SHOP DRAWING REVIEW

**BRIDGE RAIL DETAILS SHEET**

ROCHESTER, BR# 0162 (17) VT RTE 73 (MAJOR COLLECTOR), BRIDGE NO: 16, OVER CORPORATION BROOK TOWN OF ROCHESTER, COUNTY OF WINDSOR, VT

DRAWING NO. FR L - ROCH-BR16

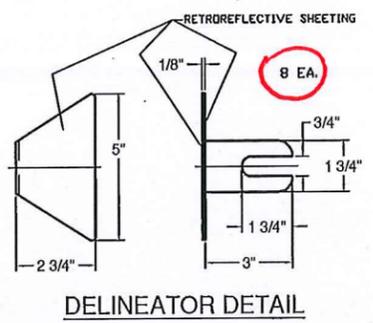
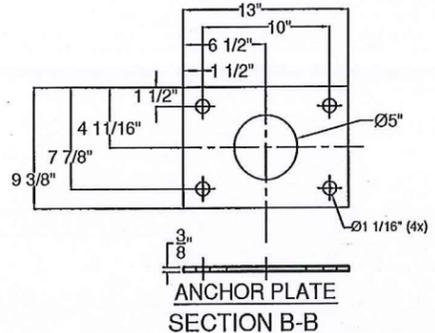
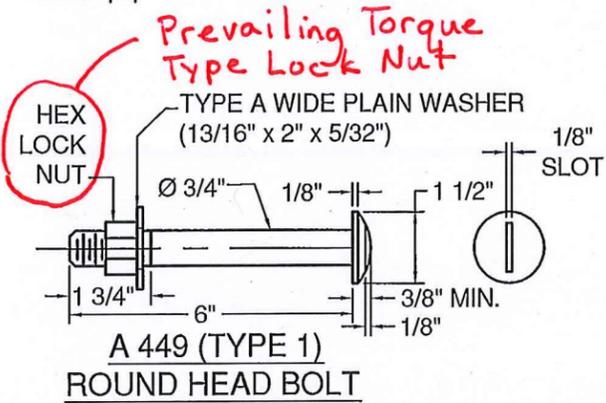
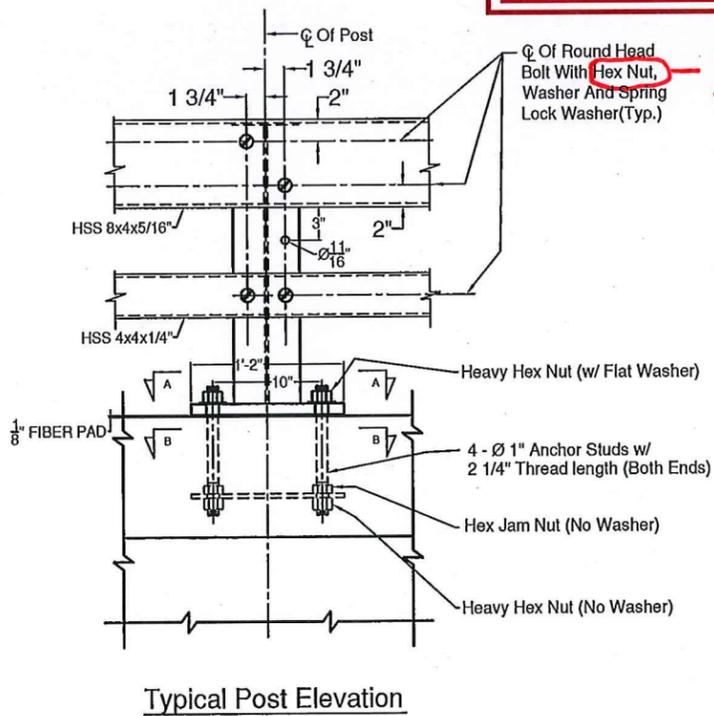
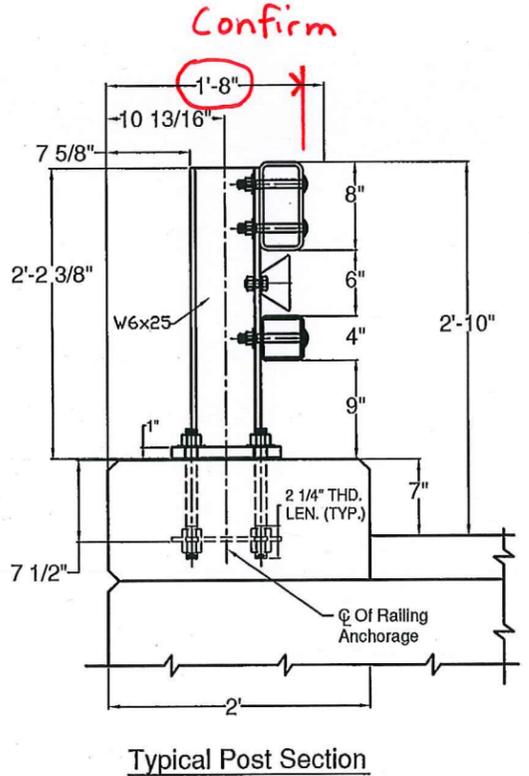
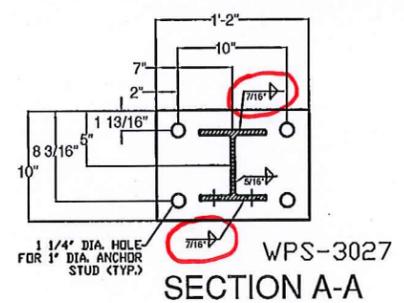
BILL OF MATERIAL			
QTY	PART #	DESCRIPTION	ASTM DESIGNATION
18	0033.90344	TWO RAIL POST @ 2'-2 3/8" O.A.	A572 Gr. 50
4	0033.91123	4" X 4" X 1/4" RAIL @ 19'-11 1/2"	A500 Gr. B
2	0033.91124	4" X 4" X 1/4" RAIL @ 24'-10"	A500 Gr. B
4	0033.91125	4" X 8" X 1/4" RAIL @ 19'-11 1/2" <i>Confirm</i>	A500 Gr. B
2	0033.91126	4" X 8" X 5/16" RAIL @ 24'-10"	A500 Gr. B
4	0033.90052	3" X 3" X 5/16" FIX. SPL. TUBE @ 1'-8"	A500 Gr. B
4	0033.90033	3" X 7" X 3/8" FIX. SPL. TUBE @ 1'-8"	A500 Gr. B, A36
18	0033.00299	3/8" X 9 3/8" X 13" ANCHOR PLATES	A36
18	0033.00052	1/8" FIBER PAD @ 10" X 14" (S-360A)	AASHTO M251
72	0042.21012	Ø 1" X 12" ANCHOR STUDS W/ 2 1/2" THREADED ENDS	A449 Gr. 1
144	0080.18901	Ø 1" HEAVY HEX NUTS	A563
72	0080.18905	Ø 1" HEX JAM NUTS	A325
72	0080.18911	Ø 1" FLAT WASHERS	F436
72	0080.06290	Ø 3/4" X 6" ROUND HEAD BOLT, NUT, FLAT WASHER, L.W.	A449, A563, ASME B18.21.1
32	0080.05045	Ø 5/8" X 1 3/4" HEX BOLT, & F.W.	A307

*Prevailing Torque Type Lock Nut*

*See Weld Procedure Sheet (Typ)*
